Enderby Wharf, Christchurch Way, SE10

planning application no. 10/3063/F

Strategic planning application stage 1 referral (new powers)

Residential-led mixed use redevelopment of an industrial site comprising, 770 residential units, Cruise Liner Terminal, 251 bed hotel, refurbishment and extension of Listed Enderby House into a restaurant/cafe & exhibition/information centre, commercial & retail units, skills academy, creche and Gym

Figure 1: site layout

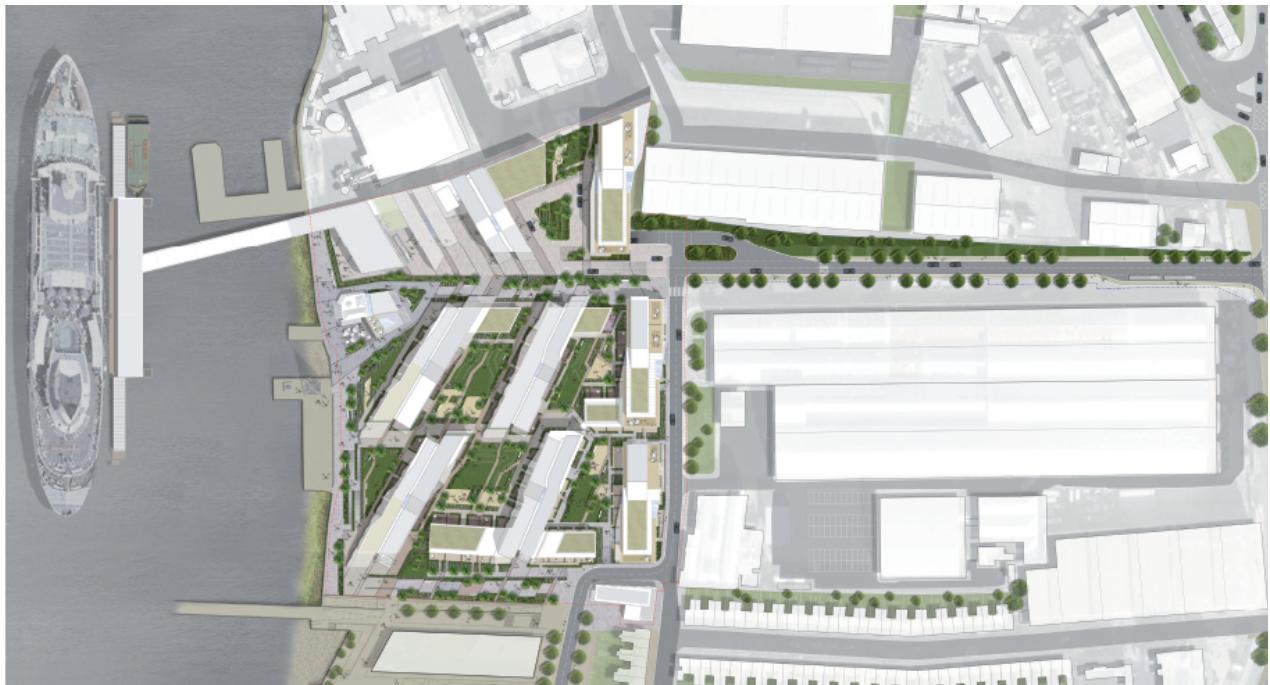
32 The proposed layout, though irregular in plan, has much to commend it and would generally support the prevailing movement patterns in the area. In particular it would create a generous riverside space incorporating Enderby House, which would support the reuse of this building and the use of the riverside path. It would maintain and enforce the alignment of Christchurch Way and connect this, and Banning Street, with perpendicular streets running to the riverfront. This would form a discrete urban block, well proportioned in terms of the wider urban grain and presenting residential entrances and active ground floor uses to the public routes on all sides. The internal planning of this urban block is more irregular with the arrangement of individual blocks being driven by orientation to the river and sun. The internal communal amenity spaces this creates would nonetheless be well proportioned in relation to the scale envisaged and the area required for amenity in a scheme of this size.

33 The positioning of the hotel and cruise ship terminal against the safeguarded wharf to the north of the site is sensible, given the associated amenity issues. It is notable that the noise assessment appears to be based on a non operational wharf at Tunnel Glucose to the immediate north of the site. As a safeguarded wharf, this site is expected to come back into wharf cargo handling use and will therefore be a source of noise. The applicant should provide further design and supporting acoustic analysis to satisfy officers that the design of the hotel, cruise terminal and residential Block A, adjacent to the safeguarded wharf on the northern boundary, would be satisfactory in terms of amenity and avoid prejudicing the ongoing operation of the safeguarded wharf for wharf related uses. Furthermore this analysis should ensure that the landscaped area between Block A and the hotel does not allow noise to impact further into the site. If this cannot be proven then the design of this area should be reconfigured.

35 The proposed route running east from the Christchurch Way to Blackwall Lane clearly presents a number of design challenges as, whilst it is positive in terms of improving connections to the east, it will be largely flanked by the blank facades of existing industrial buildings which are set to remain for the foreseeable future. The public realm treatment, especially the lighting, and the management plan should ensure that this area attains an adequate level of amenity and security for users. The applicant should ensure that this and all other routes proposed connect with the existing routes in the area, including Christchurch Way and Banning Street, to allow easy and direct vehicular and pedestrian movement through the area and support its legibility. It is disappointing that more detailed landscaping drawing have not been provided for this difficult area. The Council should ensure through the addition of conditions that the design of this area would meet these objectives and attain an appropriately high level of design quality.
